December 17, 2015

Re: **Rosemont Mine – Surface Water Impacts, Davidson Canyon and Cienega Creek**

RE: New analysis of stormflow and groundwater data from Davidson Canyon:
Evidence for influence of stormwater recharge of groundwater

Figure 2. Change in depth to water (feet) at the Davidson #2 Well (black dots) in relationship to stormflow at the Davidson Canyon Gauge, 2015.

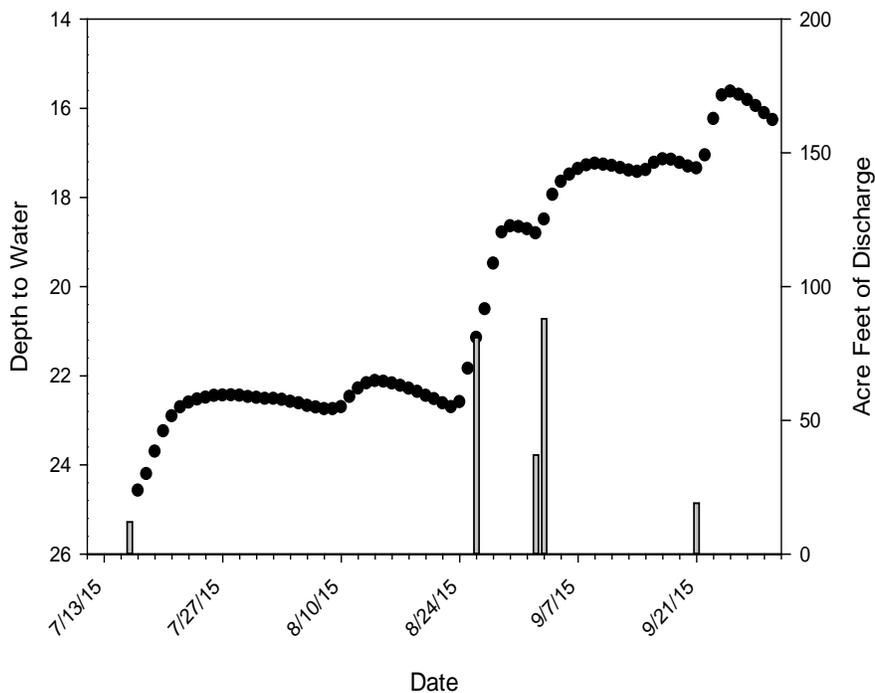
Importance of Streamflow to Aquifer Recharge in Davidson Canyon. In this next analysis, we compare the daily change in well depth at Davidson #2 Well to stormwater flows in Davidson Canyon (Fig. 2), baseflow at Barrel Canyon (Fig. 3) and Barrel and Davidson canyon stormflow (Fig. 4).

A direct relationship between surface water flow and depth to water is evident for almost each period of time well depth increased. This phenomenon is preceded by stormflow in Davidson Canyon and/or measured flow in Barrel Canyon. An exception is an increase in recharge in the middle of September that is not associated with either of these measures, which also underscores the fact that there are many tributary inputs into Davidson Canyon below Barrel Canyon and not all of these may be recorded as stormflow at the Davidson Canyon Gauge.

Figure 5. Daily difference in groundwater levels (as measured at the Davidson #2 Well) in relationship to stormwater events. (Y)es = on or four days after a stormflow event; (N)o before or more than four days after a recorded stormflow event.

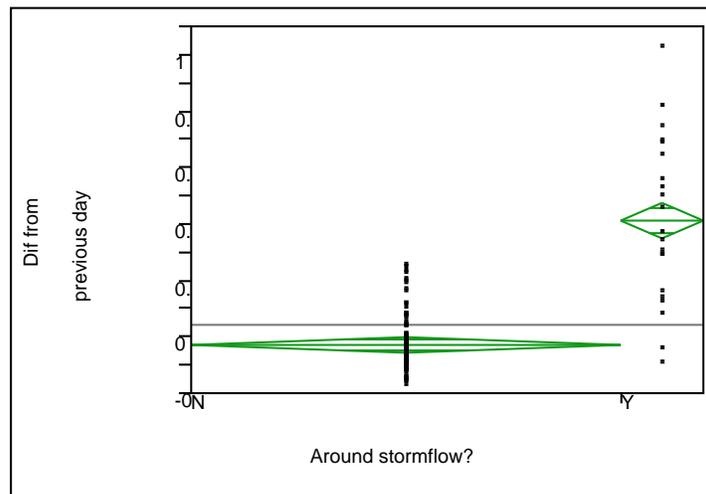
We then took a more quantitative approach by looking at the daily change in well depth as a function of the relationship to stormflow, as measured at the Davidson Canyon Gauge. To do this we grouped change in well depth for each day into one of two categories in relationship to stormflow: 1) Yes(Y) = day was on or four days after a stormflow event or 2) No(N) = day was before or more than four days after a recorded stormflow event. The results show that there is strong statistical relationship between daily change in well depth and stormflow events (Fig. 5; 2-way t-test, $t_{128} = 12.6$, $P < 0.0001$, 95% confidence interval for "No" = -0.057 to -0.0014, "Yes" = 0.349 to 0.475). Thus, there is strong evidence for groundwater response at Davidson #2 well to storm water flow inputs recorded at the Davidson Canyon gauge.

Figure 6. Relationship between length of flow in Davidson Canyon and depth to water at the Davidson #2 Well. The linear model (red line) explains 71% of the variation in the data. The most recent observations (green dots) are from September and November 2015.

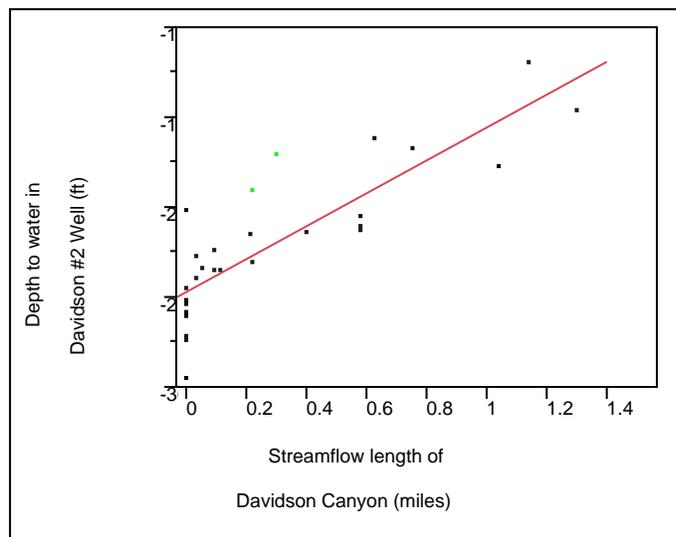
The relationship between streamflow length and depth to water in Davidson #2 Well remain strong. In this memorandum we also update the analysis of data from Davidson Canyon relating streamflow length in miles to depth of water in the Davidson #2 Well. These data were first reported in Powell et al. (2014; Figure 5) and used data from 2005-2013. Since that time, we have obtained three new data points: June 2014 and September and November 2015. Figure 6 shows the results, indicating the relationship reported in 2014 holds today, though two of the three most recent observations are further above the regression line, meaning that flow lengths are shorter than would be predicted based on the DTW. An interesting note is that most other observations above the regression line (and where there is flow in Davidson) occur during fall and winter months.

- 3) The new analysis of the relationship between depth to water and length of streamflow in Davidson Canyon, which used three new data points, reaffirms an earlier analysis by Powell et al. (2014) for a strong statistical relationship between these two variables. That is, as groundwater levels rise and fall, so too does the length of flow in Davidson Canyon increase and contract (Fig. 6);

Figure 7. Relationship between length of flow in Davidson Canyon and other variables, from multiple linear regression model. The model (red line) explains 88% of the variation in the data. The most recent observations (green dots) are from September and November 2015.

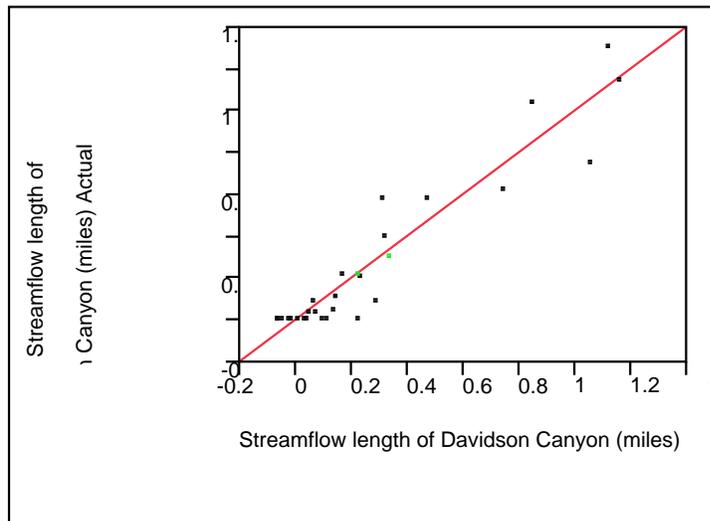
We furthered our analysis of these data by adding three additional variables into a multiple linear regression analysis (depth to water as the response variable): month, year and month*year interactive effect. The resulting model accounted for 88% of the variation in the data (Fig. 7; $R^2 = 0.88$, $F_{9,29} = 16.96$, $P < 0.001$). Of course, the relationship to depth to water explained most of the variation (as reported in Figure 6),

but the September sampling period and September sampling * year were also statistically significant ($P < 0.01$). Year explained relatively little in the model, but during the period of analysis, presence of surface flow was relatively infrequent during the time period covered by the available data (i.e., 2005 and later). Especially before 2005, visits by Pima Association of Governments staff and others noted perennial water in Davidson Canyon in the winter and spring (Pima Association of Governments 2005), which highlights both the current drought conditions and the historical winter flow in Davidson Canyon.
